SUBJECT: Response to NRC Staff Follow-Up Questions 5 through 15 from
November 9, 2001 Meeting Regarding a TMI Unit 1 Steam Generator
Severed Tube

**THREE MILE ISLAND, UNIT 1 (TMI UNIT 1)
OPERATING LICENSE NO. DPR-50
NRC DOCKET NO. 50-289**

**Response to NRC Follow-Up Questions 5 Through 15 from
November 9, 2001 Meeting Regarding the TMI Unit 1
Steam Generator Severed Tube Root Cause**

Figure 1: Top-Span Fluid-Elastic Stability Margins of In-service, Plugged and Swollen Tubes

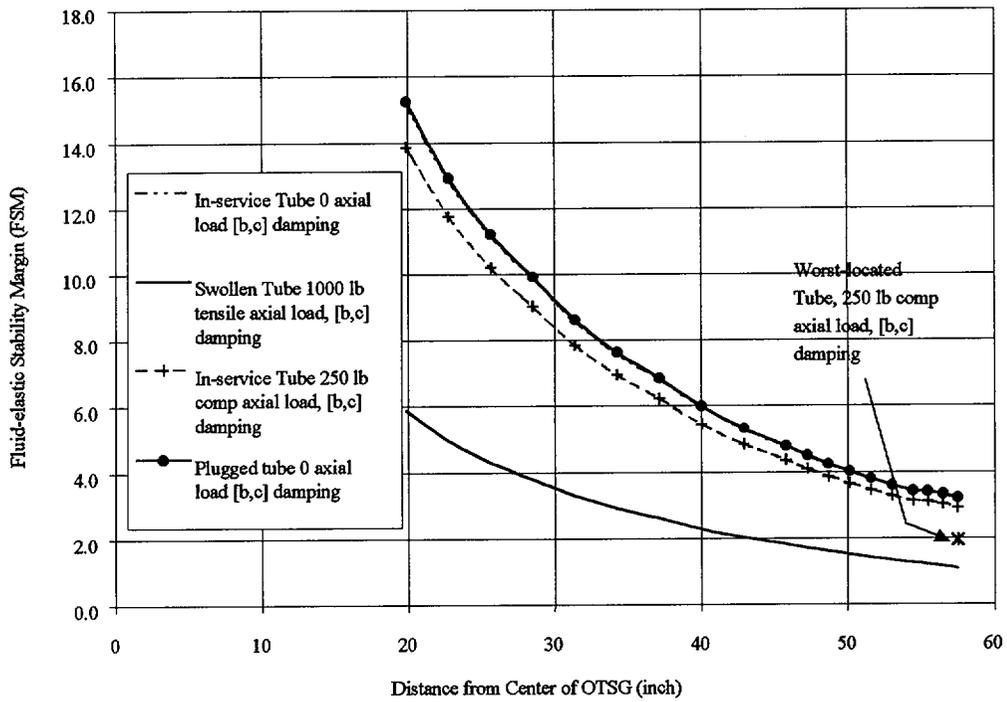
10. Describe nominal FIV response (e.g., stability ratios or some other figure of merit) under normal operating conditions at key locations in the bundle, including Regions 1, 2, and 3. Are these nominal FIV responses high enough to contribute to fatigue usage factors? What is the associated alternating stress and mean stress level?

As shown in Figure 1, under normal operating conditions, the fluid-elastic stability margins (FSM) – defined as the ratio of the critical velocity to the mode-shaped-weighted average span cross-flow pitch (or gap) velocity – are larger for tubes close to the center of the OTSG, and are dependent on the axial load of the tubes. However, the dependence is not very sensitive below the buckling load of the tube. The computed FSM between an axial load of 0 and 250 lb compression is not large as shown in Figure 1. For the same axial load, the stability margin generally increases for tubes closer to the center of the OTSG. As shown in Column 2, Rows 1 and 2 of Table 1, at the boundary away from the lane (Region 1), the stability margin of an in-service tube with zero axial load is 3.2. With an axial load of 250 lb compression, it is still equal to 2.9. The latter would decrease to 1.9 (Table 1, Column 2, Row 3) for the tubes located at the points of highest cross-flow (peripheral tubes on both sides of the lane, or Region 2 tubes). All the above results are based on a damping ratio of [b,c]. Based on both laboratory tests on tube samples and in-air tests of a full-scale OTSG, this is a representative and still conservative damping value for an in-service OTSG

Figure 3: Bottom-Span Fluid-Elastic Stability Margins of In-service, Plugged and Swollen Tubes

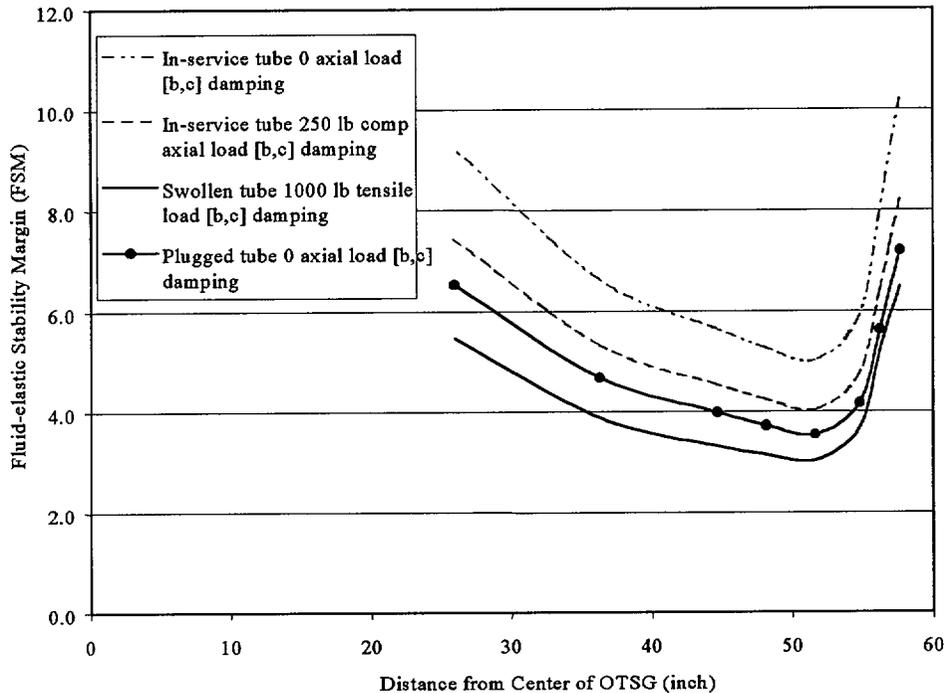
12. For plugged tubes, describe changes in FIV response in these regions for plugged tubes if tubes become swelled. Discuss all revisions to boundary conditions, applied loadings, and other model inputs and basis for these revisions.

Figure 3 shows the computed fluid-elastic stability margins (FSM) for the in-service tube with a damping ratio of [b,c]% ([b,c] basic plus 2% due to the two-phase mixture). Unlike the top span, the minimum FSM in the bottom span does not occur at the peripheral tubes. This is because as the feed water enters the tube bundle through the water ports, it is heated and changes into a two-phase water steam mixture with a much larger specific volume than sub-cooled water. The cross-flow pitch velocity increases as the mixture density decreases to satisfy the continuity equation. As the feed water enters further into the tube bundle, it starts its upward turn. In the OTSG bottom span, the maximum cross-flow velocity occurs, not at the periphery of the tube bundle, but at a point approximately 52 inches from the center of the OTSG. This is where the minimum FSM occurs. Tube B66-130 is not located at or near the point of minimum bottom-span FSM, it is almost 57 inches from the center of the OTSG.

As shown in Figure 3 and also Table 2 (Column 2, Rows 1 and 2), the minimum bottom span FSM for a normal in-service tube is 4.0. The minimum bottom span FSM of a swollen tube at the same location is 3.0. The minimum bottom span FSM of tube B66-130 is between 5.4 to 6.5. Thus, the worst-located swollen tube would have a stability margin in the bottom span higher than that of the top-span active mode of the worst-located in-service tube (Region 2).

Fluid-elastic stability margins of bottom-span active modes of plugged tubes are plotted in Figure 3 as a function of distance from the center of the OTSG and are also given in Table 2. Plugged tubes generally have smaller margins against fluid-elastic instability compared with those of in-service tubes; but have higher margins compared with those of plugged and swollen tubes. This is because the assumption that plugged tubes are filled with secondary side fluid bias the non-structural mass of the tube towards the bottom span, resulting in a larger participation from the bottom-span active modes compared with that of a in-service tube. As in in-service tubes, the smallest margin
